STAFF REPORT 10-9-2019 MEETING
APPLICATION NUMBER 19-6488
ADDRESS: 1718-1720 VAN DYKE
HISTORIC DISTRICT: WEST VILLAGE
APPLICANT: KRISTINE KIDORF
DATE OF COMPLETE APPLICATION: 9/13/2019
DATE OF STAFF SITE VISIT: 10/1/2019

SCOPE: NEW WINDOWS, LANDSCAPING, AND PARKING PAD

FIRST FLOOR PLAN

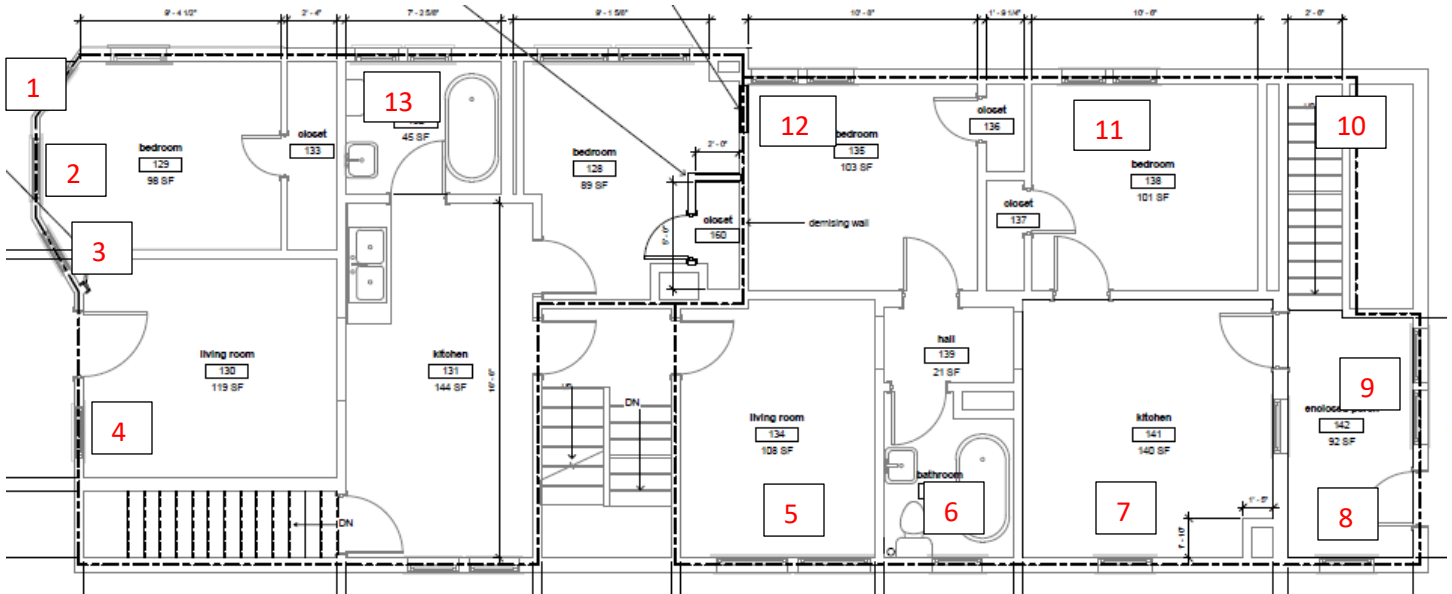
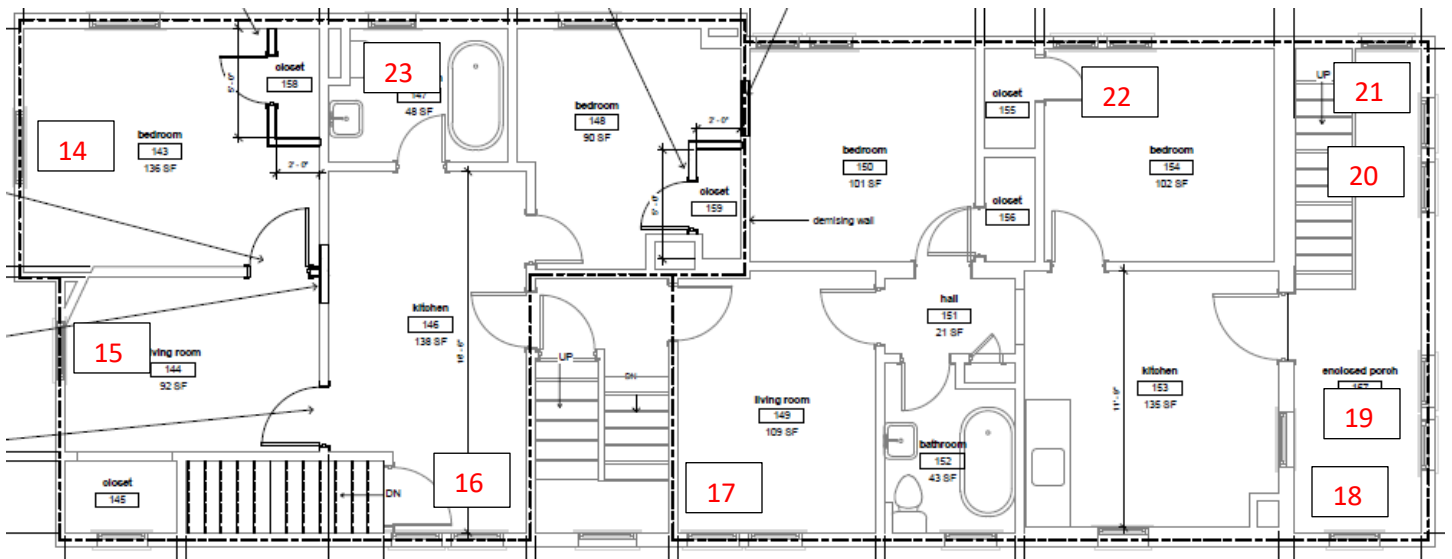
FIRST FLOOR WINDOWS (See numbers on plans above)

1 – bottom rails of both sash are deteriorated, sill is rotted, frame elements falling apart

2 – there are no interior sash – new sash laying in room which will attempted to be used, but unclear if will be able – frame rotted on exterior

3 – Frame and bottom rails of sash are rotted

4 - Frame and bottom rails of sash are rotted

5 - Pair of windows - sill rotted, frame brittle, sash are warped and bolted down on the inside

6 – Rotted frame, rotted bottom sash

7 – Rotted and brittle frame, bottom sash rail deteriorated

NOTE: windows located in the enclosed rear porch are in worse condition than in the main house, the wall structure is not as stable as the main house. This includes 1st floor windows 8-10, and 2nd floor windows 18-21. Additionally it seems like the first floor windows were salvaged from another location as they are different than any other windows in the house

2nd FLOOR

14 – upper sash rail eaten away, rotted sill

15 – Sill and bottom rotted due to splash back from porch roof – bars will be removed

16 – Rotted sill and frame, bottom sash rotted, sash warped

17 – Rotted sill and warped sash (no exterior photo)

18 – Chewed/rotted exterior trim/frame, rotted sill

19 – Rotted sill and sash

20 – Rotted sills and sash

21 – Rotted sill and sash – extra pieces on interior to hold it together

22 – interior taped together, bottom rails rotted

23 – Rotted sill and sash – high moisture area

- It is staff's opinion that the existing wood windows can be repaired
- The existing satellite dish detracts from the home's historic appearance and represents an ongoing violation

As noted above, it is staff's opinion that the windows proposed for replacement do appear that they can be replaced. Staff therefore recommends that the Commission deny the issuance of a Certificate of Appropriateness for the replacement of windows at 1718-1720 Van Dyke because the work does not meet the Secretary of the Interior Standards for Rehabilitation, standard # 6) *Deteriorated historic features shall be repaired rather than replaced. Where the severity of deterioration requires replacement of a distinctive feature, the new feature shall match the old in design, color, texture, and other visual qualities and, where*
